3.4/4.4. STANDBY LIQUID CONTROL SYSTEM

ENCLOSURE 2

DESCRIPTION AND JUSTIFICATION BROWNS FERRY NUCLEAR PLANT UNITS 1, 2, AND 3

SODIUM PENTABORATE SOLUTION
VOLUME-CONCENTRATED
REQUIREMENTS
FIGURE 3.4-1

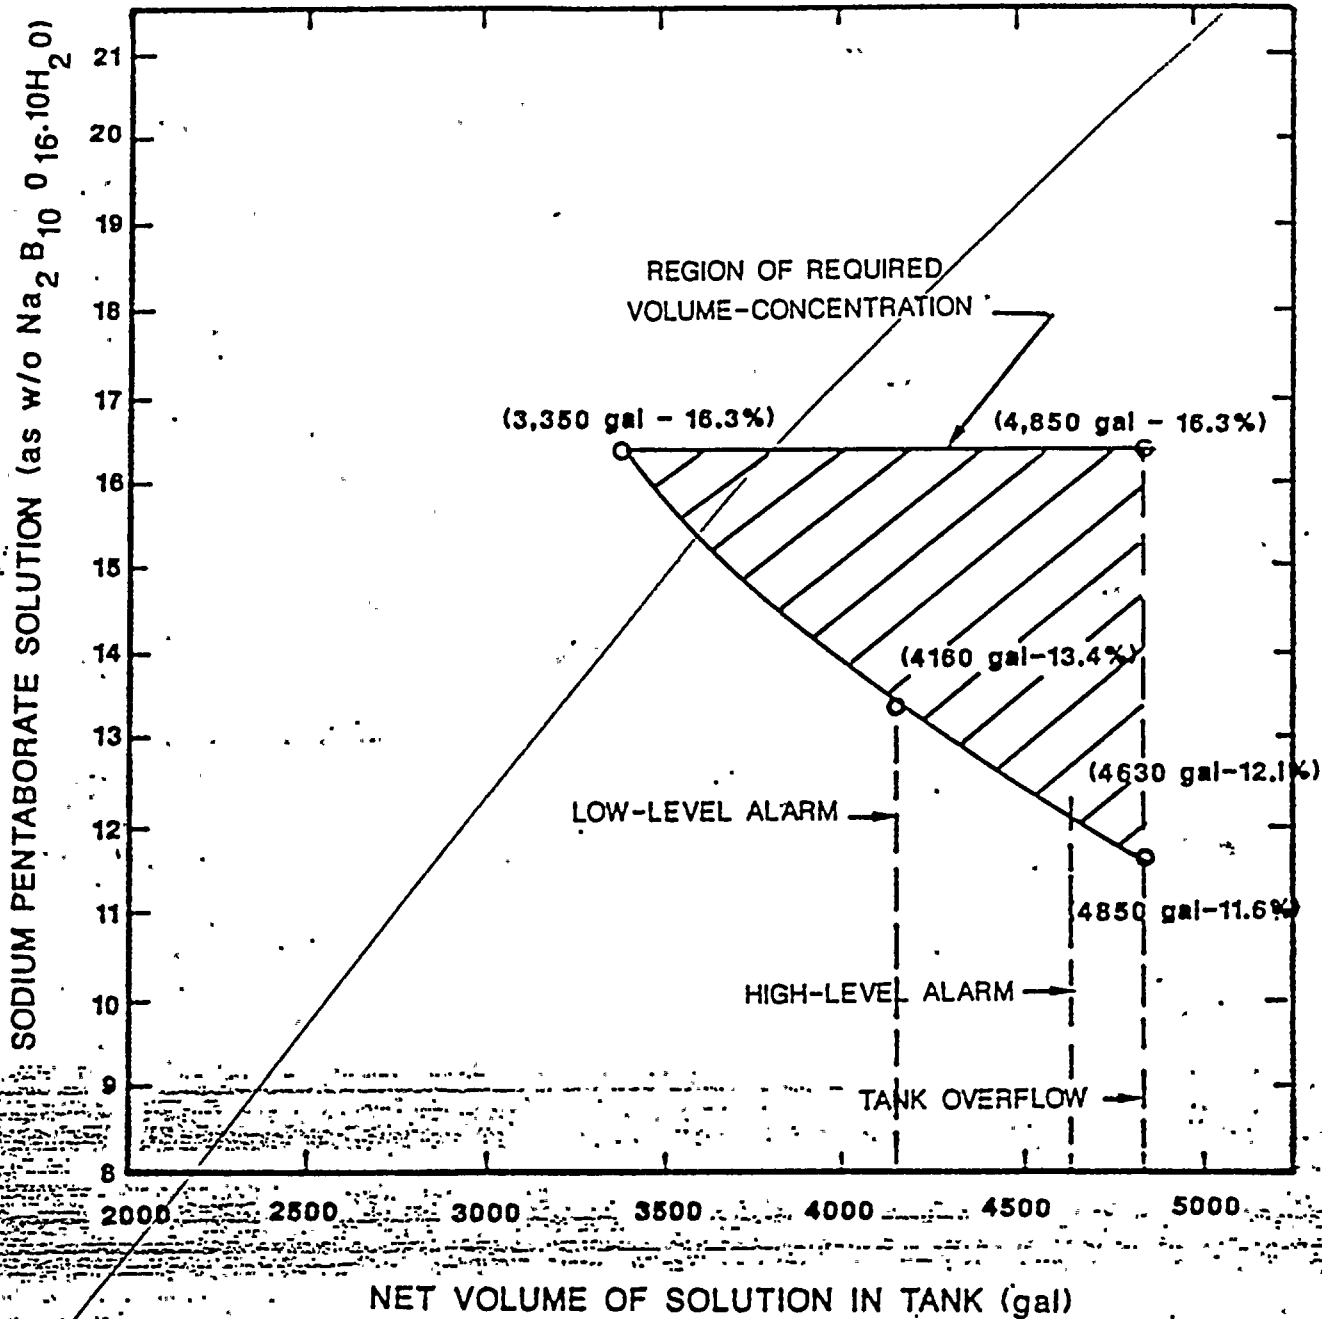
Due to the lower required concentration of sodium pentaborate and its associated saturation temperature, the requirement to monitor the solution temperature is deleted. In addition, figures 3.4-1 "Sodium Pentaborate Solution Volume - Concentration Requirements" and 3.4-2 "Sodium Pentaborate Solution Temperature Requirements" are deleted.

1. At least 180 lbs Boron-10 must be stored in the Standby Liquid Control Solution Tank and be available for injection.

2. The sodium penta borate Solution Concentration must be equal to or less than 9.2% by weight.

SODIUM PENTABORATE SOLUTION
TEMPERATURE REQUIREMENTS
FIGURE 3.4-2

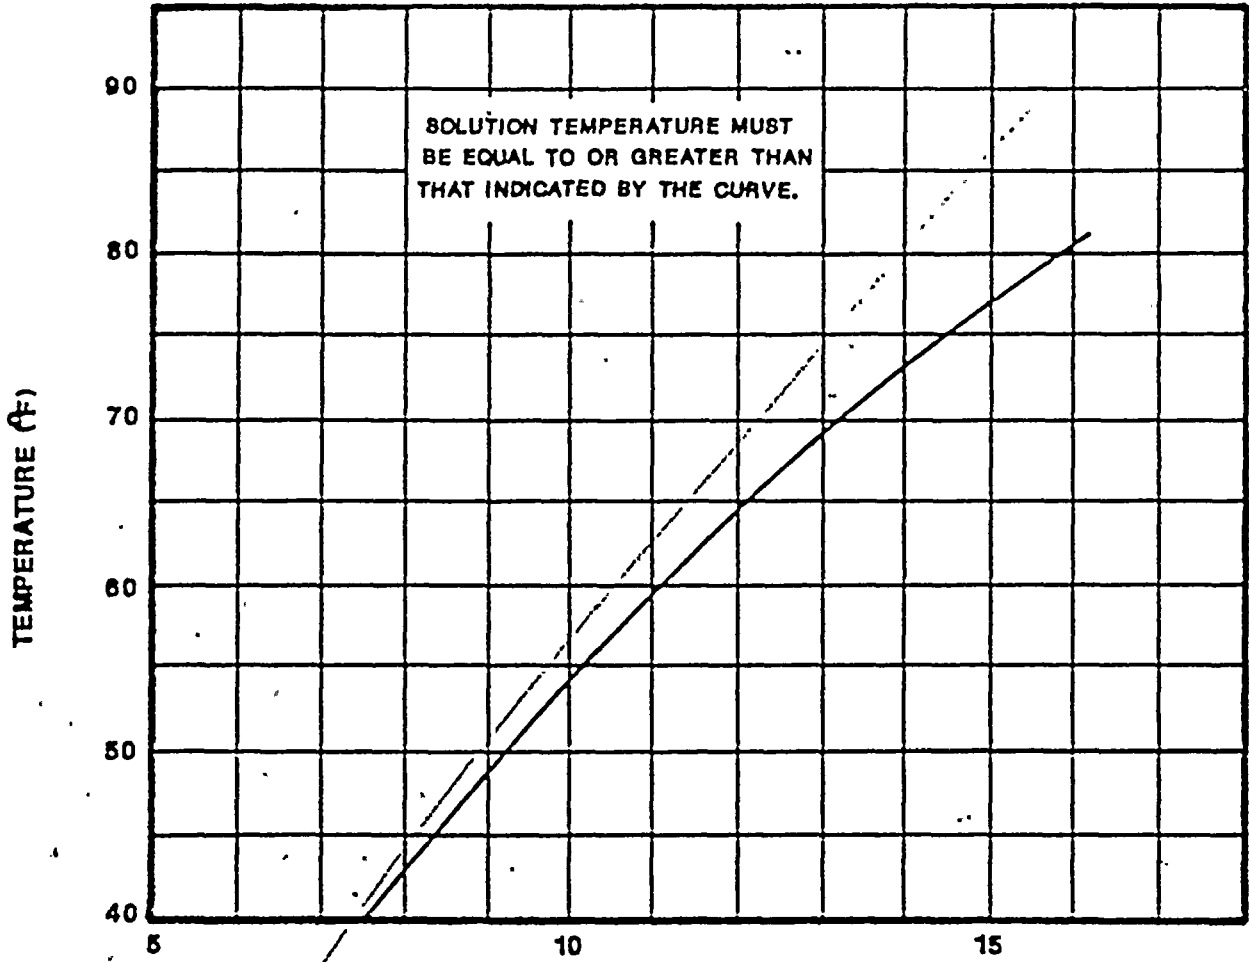
page deleted
